## ADDENDUM #1

**Project:** Blocksidge Field - Site Work  
**Date:** February 3, 2017

**Cc:** Gino Cresta, DPW Director  
**Issue No.** 1

**1** GRANDSTAND SLAB - ENLARGEMENT  
 SCALE: 1" = 10'-0"

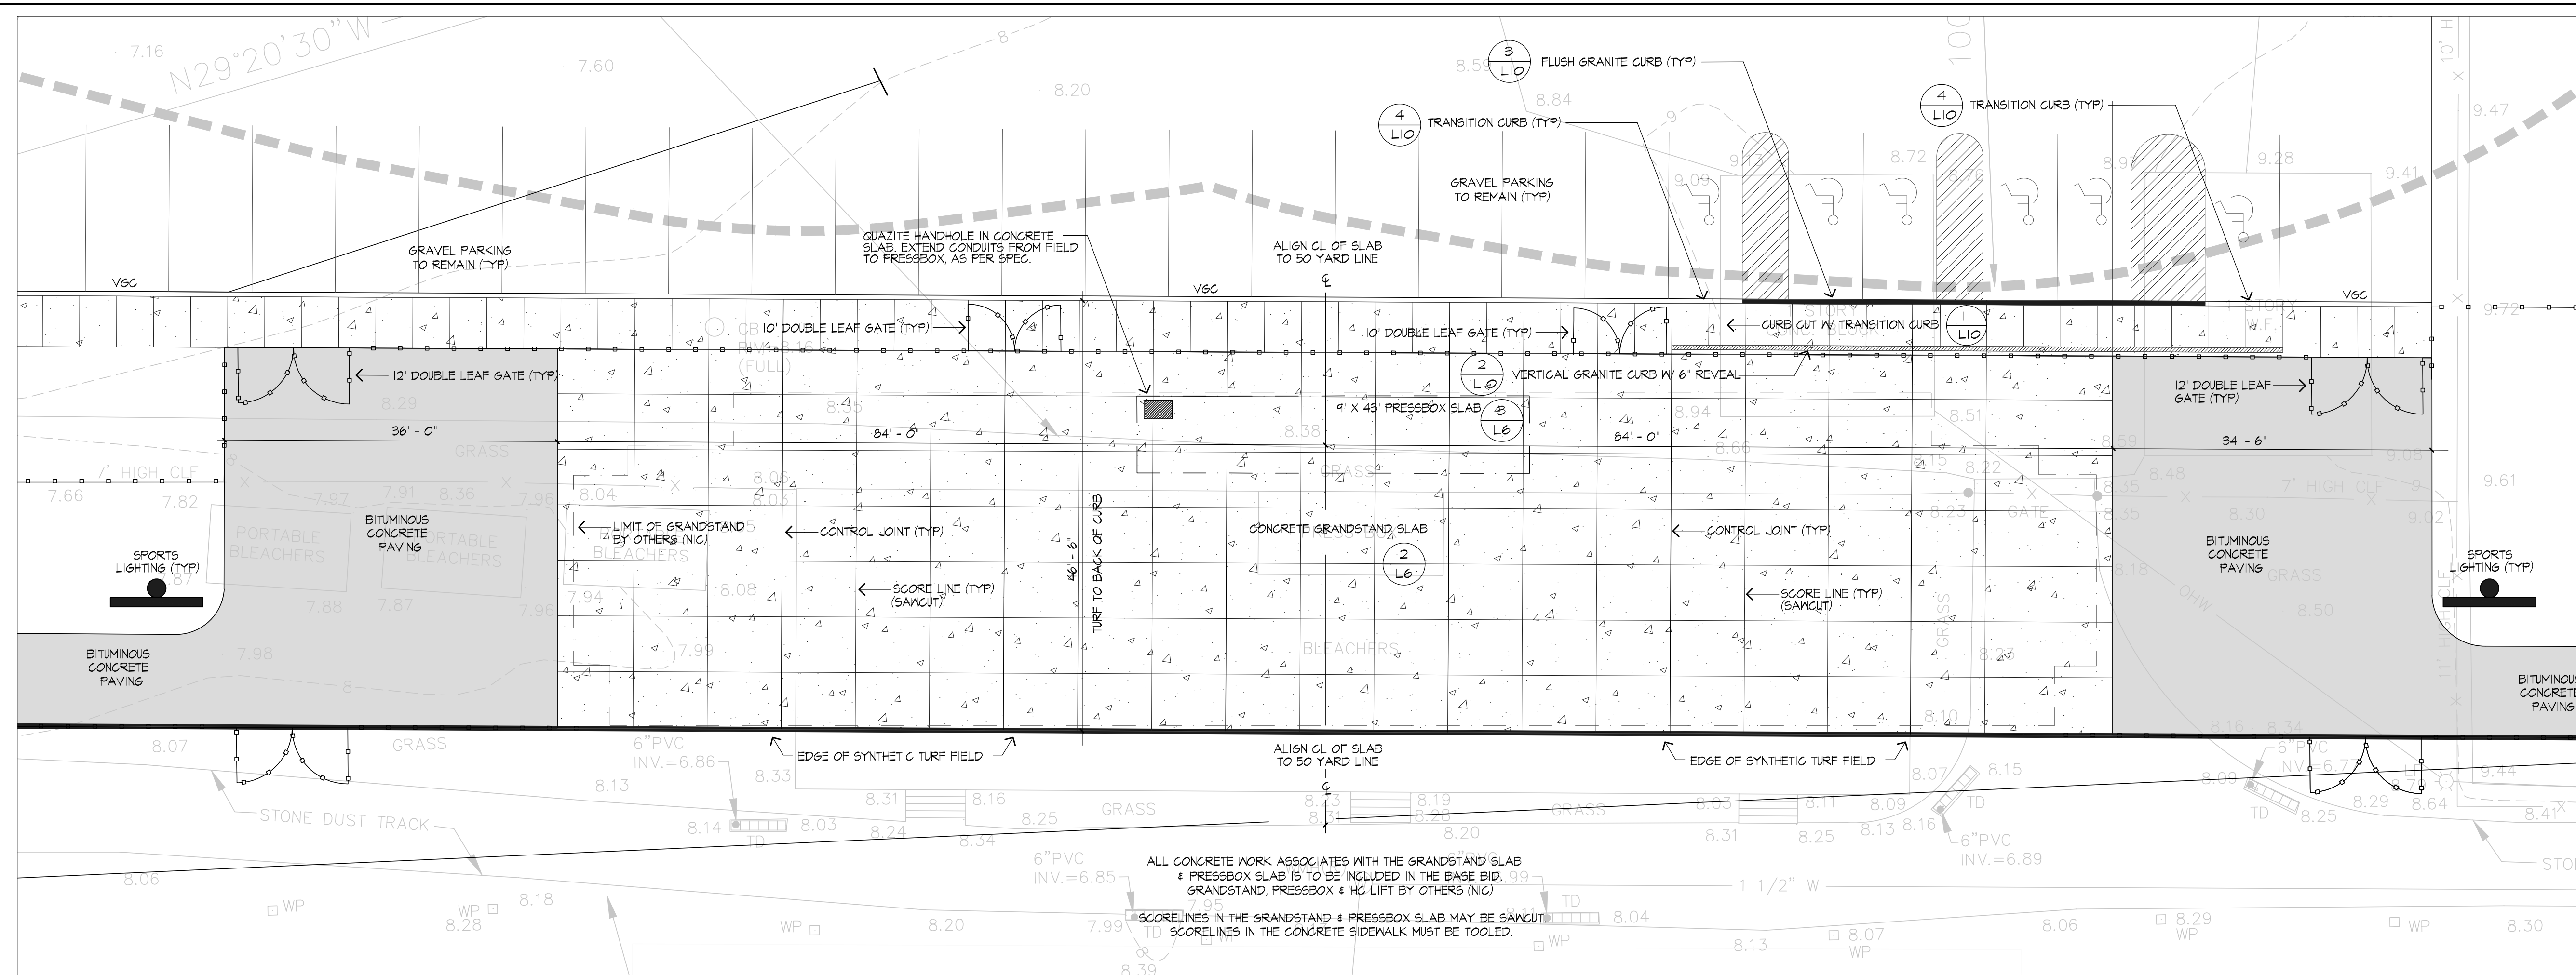
- Q5. Detail says panel drain at 20' oc, plan at 25'oc. Please confirm.  
A5. Spacing is 25' o.c., as per plan.
- Q6. Will pressbox slab be independent of grandstand slab?  
A6. Yes, Refer to revised sheet L-6, Detail # 1 & 3 for details. (Attached)

**8.0 REPLACE** Sheet L-6, dated 1.15.17 with the revised Sheet L-6, dated 2.3.17 (Attached)
